304-312 DANFORTH STREET

OUTLINE OF SPECIFICATIONS FOR GARAGE AT 310 LANFORTH ST.

Subject: Application for building permit to
cover construction of 2-car garage at 308
Danforth Street.

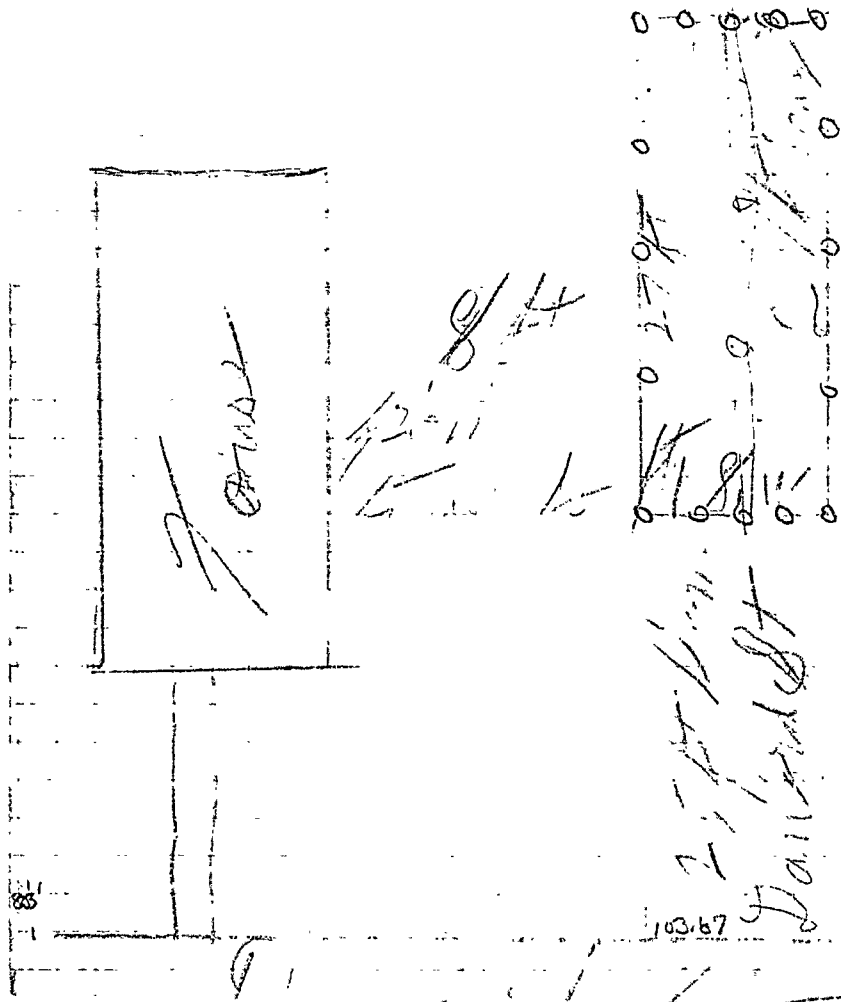
The side wall of the garage is required to be at least five feet from the side lot line. In stating out the location evidently Mr. Segee has relied upon the wire fence as being the property line. Judging from the distance of the fence from Bury Street, considerable doubt arises as to this fence being precisely on the property line, indications being that the fence may be as much as eight inches or a foot in from the side property line on the lot adjoining the Everett property. Dr. Everett will have to establish the true location of this side property line in some manner so that there will be no doubt as to the location of the garage complying with the Zoning Law.

The building is stated as only 17 feet wide instead of 14 feet wide shown on the application, and on the side toward the Everett house is directly against a stone retaining wall, which wall extends about two feet above the ground at the location of the front of the proposed garage and eight feet at the rear. There is considerable doubt if you can get a two car garage between the retaining wall and the side property line if requirement of distance from side lot line of five feet is observed. It may be that you plan to use the retaining wall as foundation of one side of the garage. If so that fact should be indicated on a more detailed plan submitted with the application.

The ground slopes off rapidly toward the rear of the lot, so that the floor of the garage at the rear would be about six feet above the ground. It is necessary that you show how this floor and the sills of the building are to be supported at such a height, whether the cedar posts are to be long enough to extend four feet below the surface of the ground and then up the six foot height or thereabouts to the underside of the sills, or how this is to be done. Please have this indicated on the plan so that we may have no doubt as to what is intended without anyone standing by to explain the plan. This height of post above ground in the rear makes a situation whereby the stiffness of the building would be helped by some bracing from post to sill, two ways at the rear.

Unless 2-inch solid plank is to be used for the flooring of the garage, the 3x10 floor joists must be no more than 13 inches from center to center instead of the 24 inches shown, and no less than 1x3 cross bridging should be used in every span. Either indicate the closer spacing or the fact that 2-inch solid plank is to be used for flooring.

After the permit is issued and construction work gets underway, no doubt Mr. Segee will see to it that the sills, center girder under floor and the 3x4 rafters are set with the larger cross-sectional dimension upright. He also ought to use something stronger than 3x4 for the hip rafters. He shows a roof which is quite flat, four and one-half inches to the foot. If the roof were actually built the least bit less in pitch than that, the 3x4 common rafters on a projected span of nine feet would not be strong enough. If material of right length is available why not make sure about this point by making the roof substantially steeper than shown?
